CONNECTION ASSESSMENT & APPROVAL PROCESS

PRELIMINARY ASSESSMENT REPORT

Project: Connect the proposed Pillette Road 115/13.8kV Substation

CAA ID No. 2001-039

Proposed facilities at DaimlerChrysler Pillette Road Substation

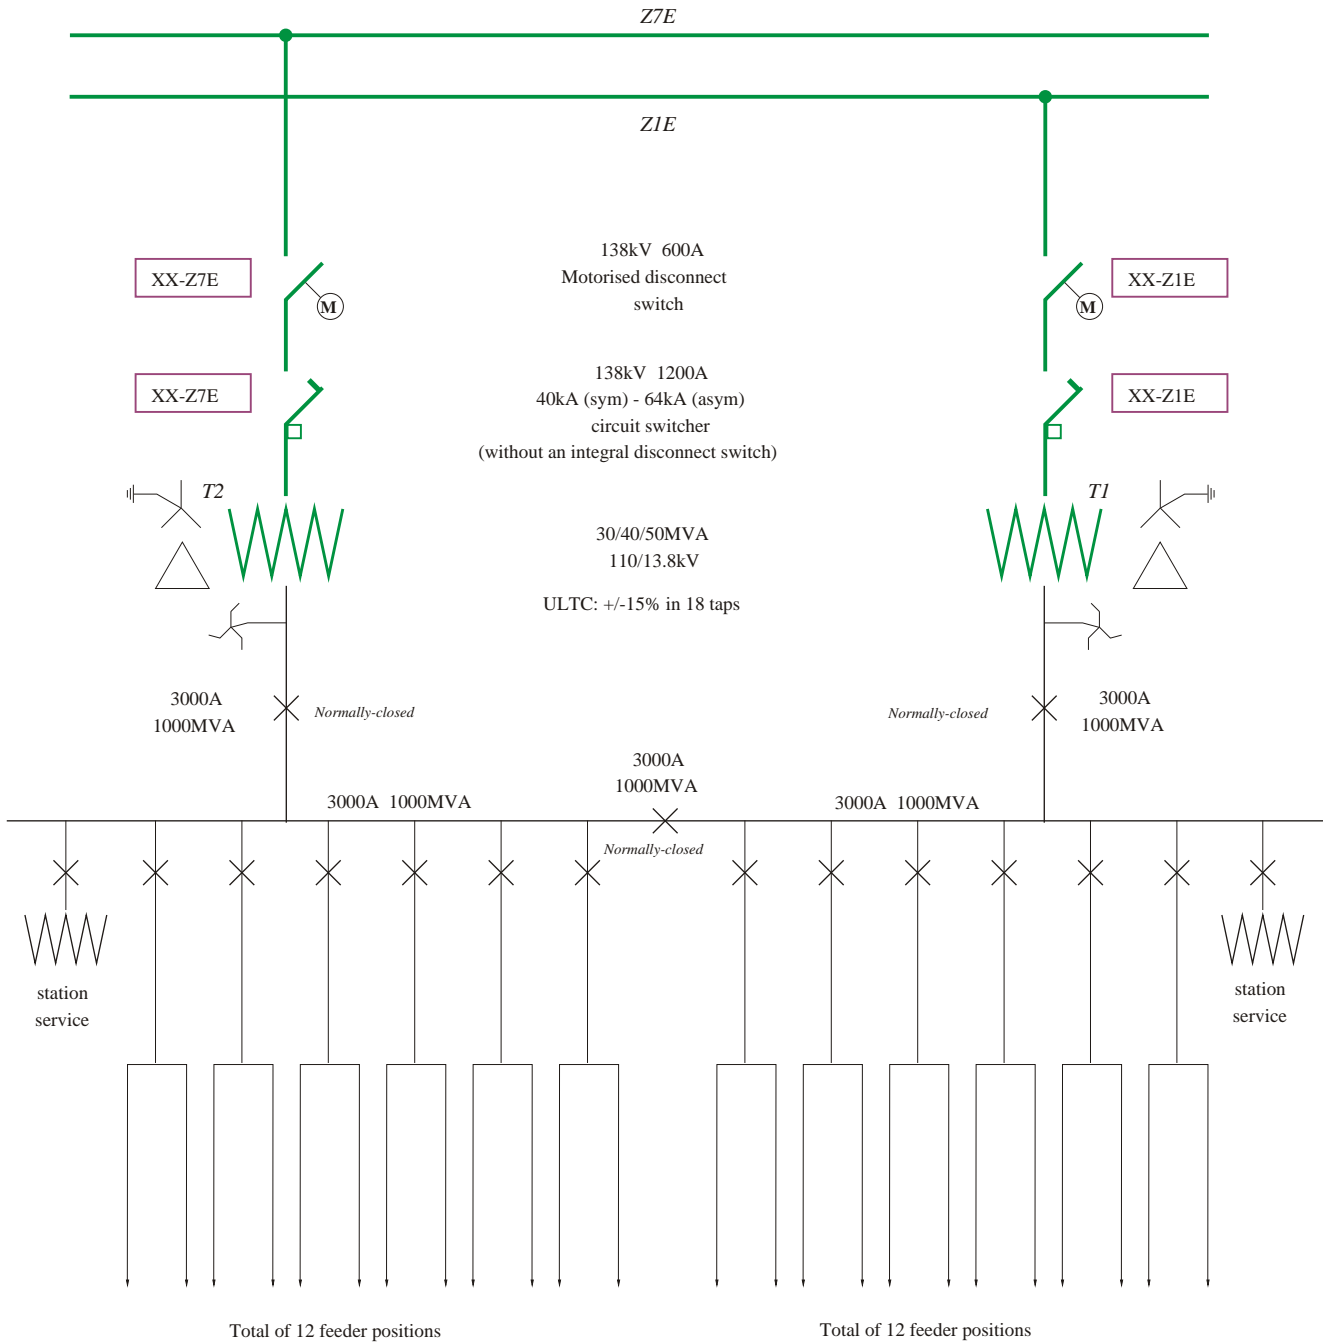
Each transformer at the new Substation is to be switched via a 115kV SF₆ circuit switcher that consists of a separate SF₆ 'puffer unit' without an integral disconnect switch, and a series connected 115kV motorised disconnect switch.

The fault interrupting capability of the circuit switcher is 40kA symmetrical and 64kA asymmetrical, while its continuous rating is 1200A.

The continuous rating of the motorised disconnect switch is 600A. (~125MVA at 120kV)

Since the circuit switchers that are to be installed at the new substation is only rated at 40kA (symmetrical) they would not comply with the Code. However, a review of recent fault level studies has shown that this rating would be adequate for fault interrupting duty for the present system, as well as when the new Brighton Beach generating facility that ATCO Power is present constructing at Keith TS is in-service.

The installation must also be fully compliant with the provisions of the Transmission System Code, and will therefore require that the remote trip and transfer trip protection signals be duplicated.

It is also recommended that the layout of the proposed new substation should be modified to include provision for the future installation of shunt capacitor banks on the expectation that these will be required to meet the power factor requirements of the Market Rules.

Should new generating facilities be added to the system or new transmission facilities be installed then these could increase the fault level beyond the rating of the circuit switchers. At that time, DaimlerChrysler would be required to replace the circuit switchers with higher-rated devices, or to restrict their operation to normal switching duties and also for back-up fault clearance in the event of an LV breaker failure condition.

Windsor Area Overload Protection Scheme
Effect of a Mode 1 Split in Response to a J3E Contingency

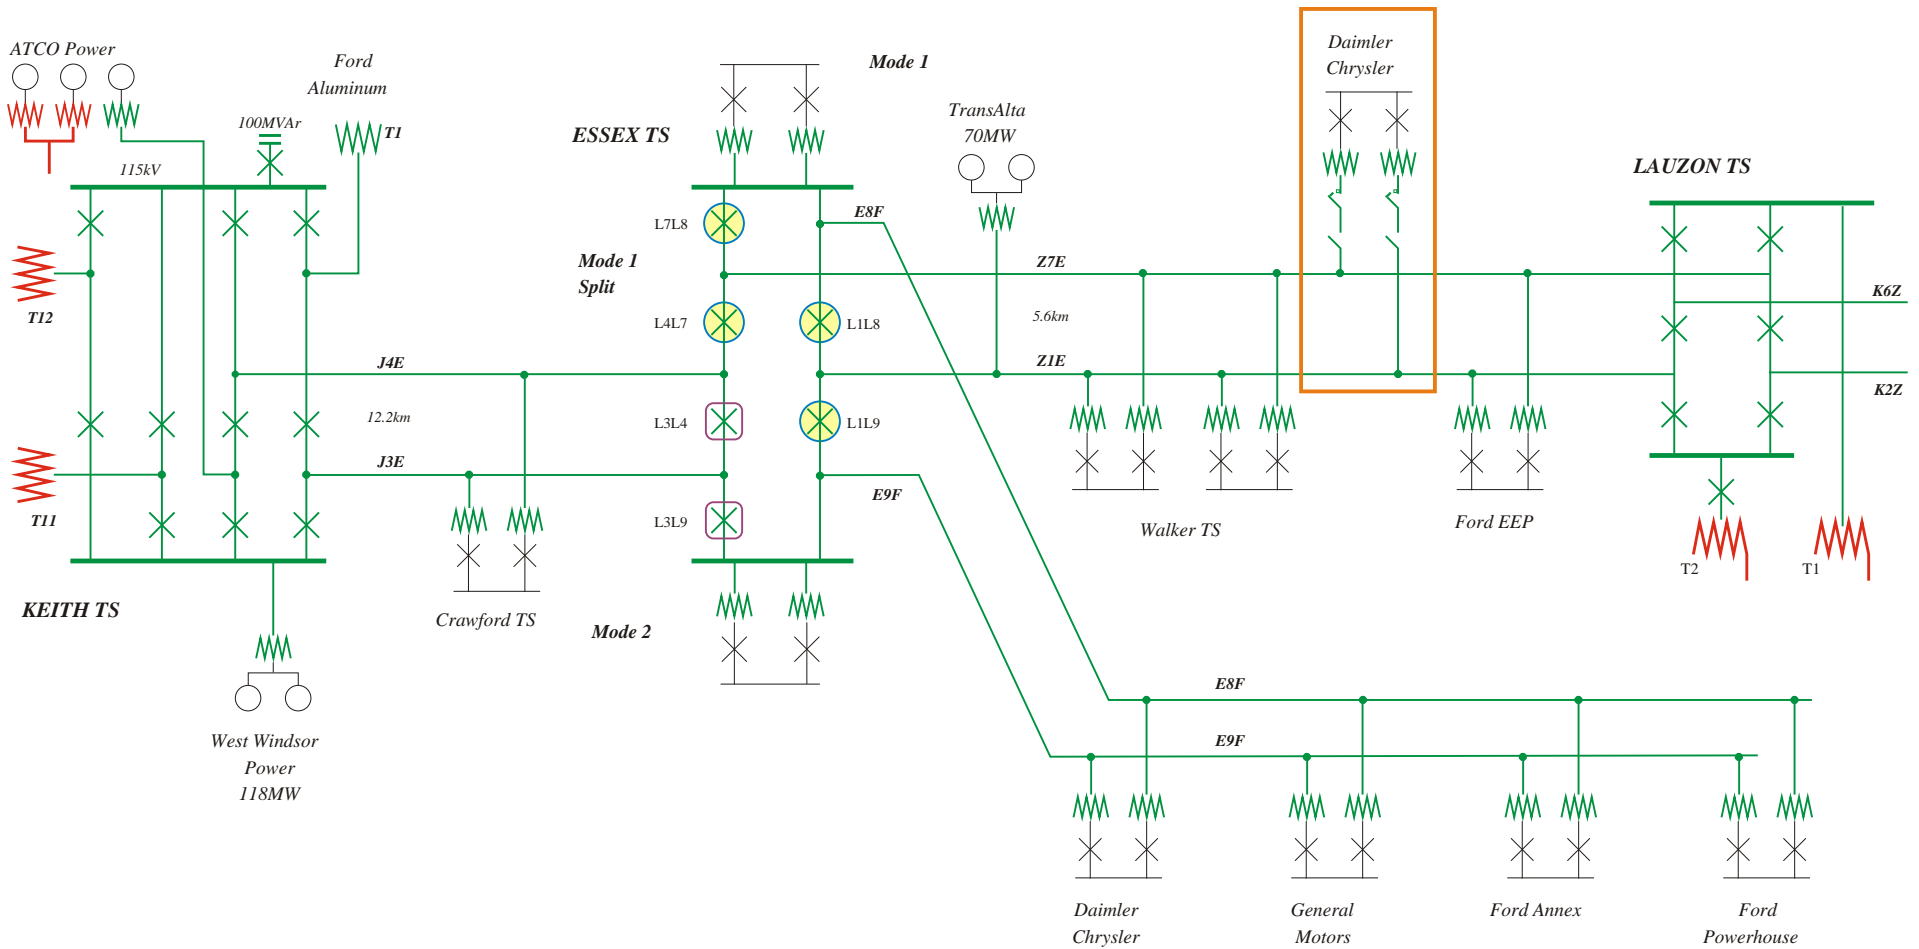
Diagram 4 shows the effect on the existing system configuration, of a J3E contingency, followed by a Mode 1 split of the 115kV system. Breakers L3L4 & L3L9 would open initially in response to the J3E contingency. Breakers L1L8 & L1L9 and L4L7 & L7L8 would then open to isolate circuits Z1E and Z7E, respectively, from the loads at Essex TS and the automotive loads on circuits E8F & E9F: to achieve the required Mode 1 Split.

With the present termination arrangement at Essex TS, this switching sequence would end up rejecting all the load at Essex TS, together with that at the automotive plants supplied from circuits E8F & E9F.

Proposed Revision of the Existing Terminations at Essex TS

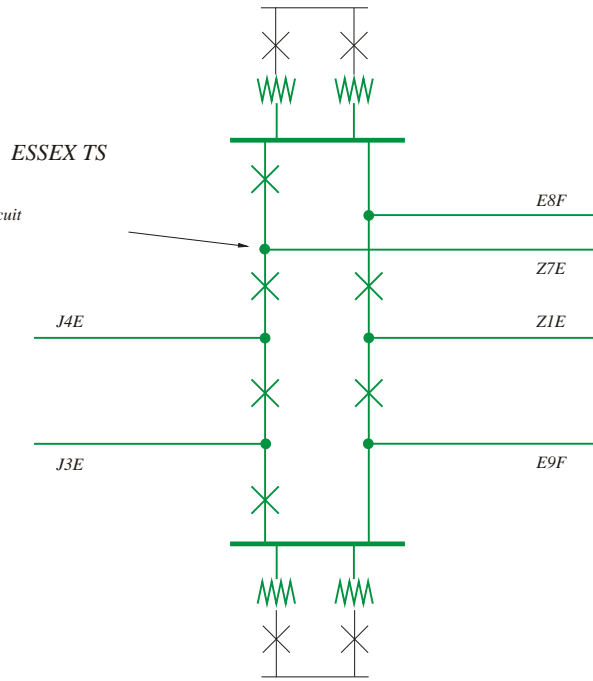
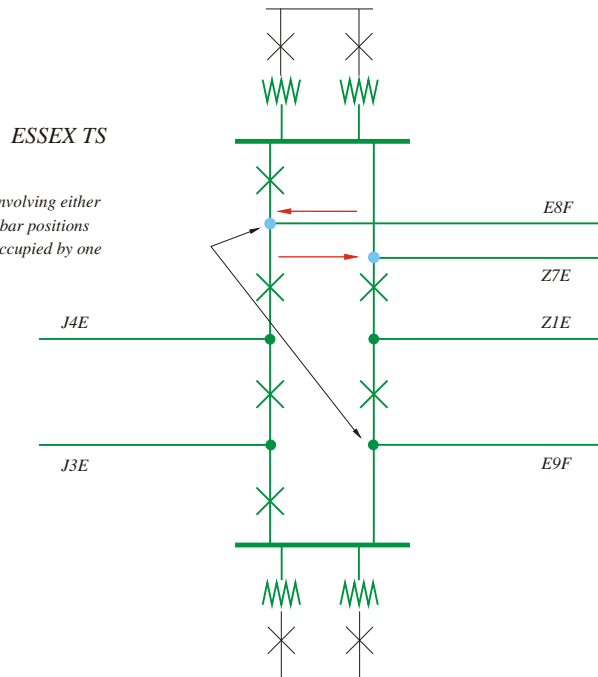
Diagram 5 shows the existing termination arrangement at Essex TS and the revisions that would need to be made to allow a Mode 1 split of the 115kV system to be initiated in response to a J3E contingency. The proposed rearrangement of the 115kV busbar would result in each of the ExF circuits being directly adjacent to one of the JxE circuits. In the event that one of the JxE circuits experiences a contingency, the companion circuit would then be available to supply the automotive loads via the remaining ExF circuit.

The busbar position directly adjacent to circuit J4E is presently occupied by circuit Z7E

As mentioned in Section 5, it will also be necessary to revise the termination arrangement of the circuits at Essex TS, so that a Mode 1 split of the 115kV system can be initiated following a contingency involving circuit J3E. This will require the terminations for circuits E8F and Z7E to be interchanged.

To allow a Mode 1 split for a contingency involving either of the Keith TS to Essex TS circuits, the busbar positions directly adjacent to these circuits must be occupied by one of the ExF circuits

DIAGRAM 6

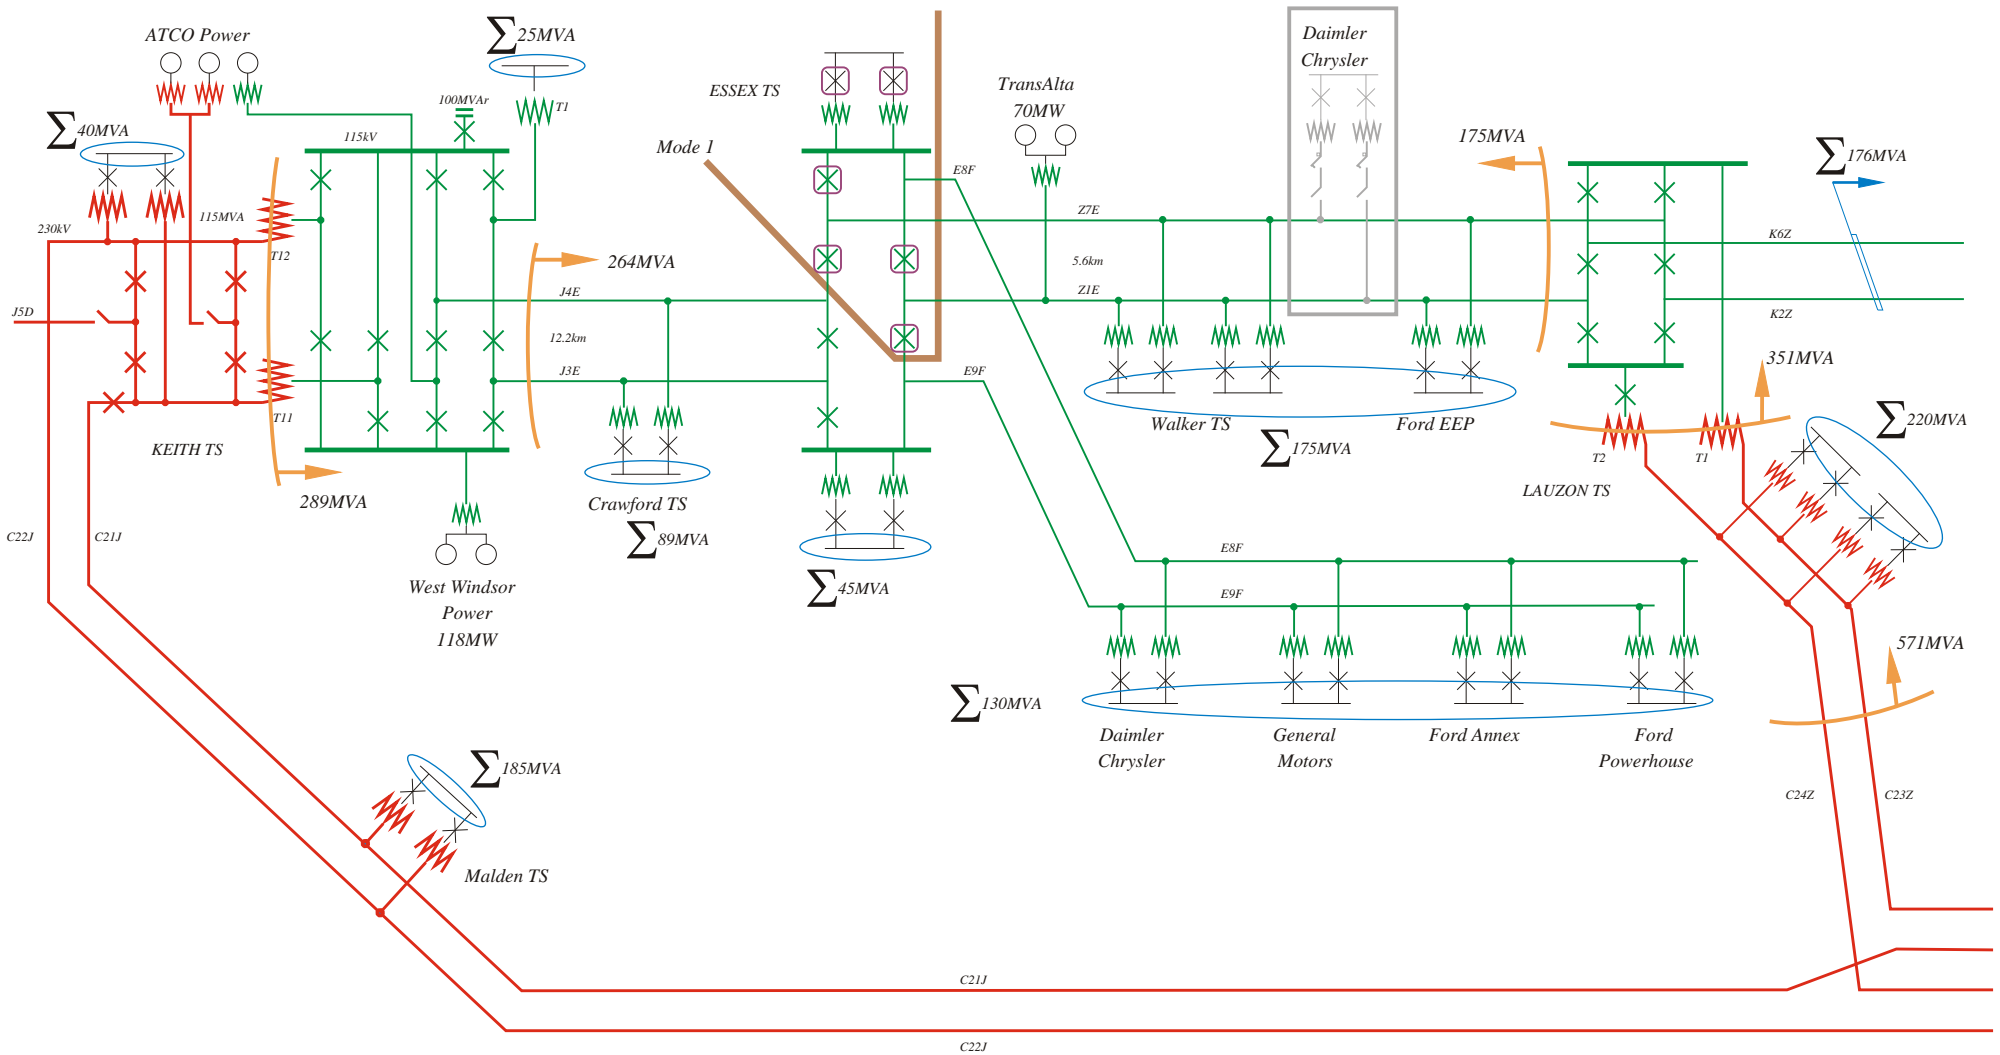
- For a contingency involving circuit J3E or J4E, under *existing* peak load conditions, the post-contingency flow on the companion circuit would exceed its 15-minute limited-time-rating (for a J4E contingency) or its emergency rating (for a J3E contingency).

- For a contingency involving circuit Z1E or Z7E, under *existing* peak load conditions, the post-contingency flow on the companion circuit would remain within its continuous rating.

At Keith TS The flows through the two auto-transformers would exceed their continuous rating, but remain within their 10-day rating.

- A Mode 1 split of the 115kV system in response to a contingency involving either of the 230/115kV auto-transformers at Keith TS would result in transfers that would exceed the 15-minute LTR of the remaining auto-transformer at Keith TS, assuming no generation capacity is in-service and ignoring losses:

- A Mode 1 split of the 115kV system in response to a contingency involving either of the 230/115kV auto-transformers at Lauzon TS, with no generation capacity in-service and ignoring losses, would result in a transfer that would remain within the 15-minute LTR of the remaining auto-transformer at Lauzon TS. However, once losses have been factored in, the transfer is expected to exceed the 15-minute LTR of the auto-transformer.
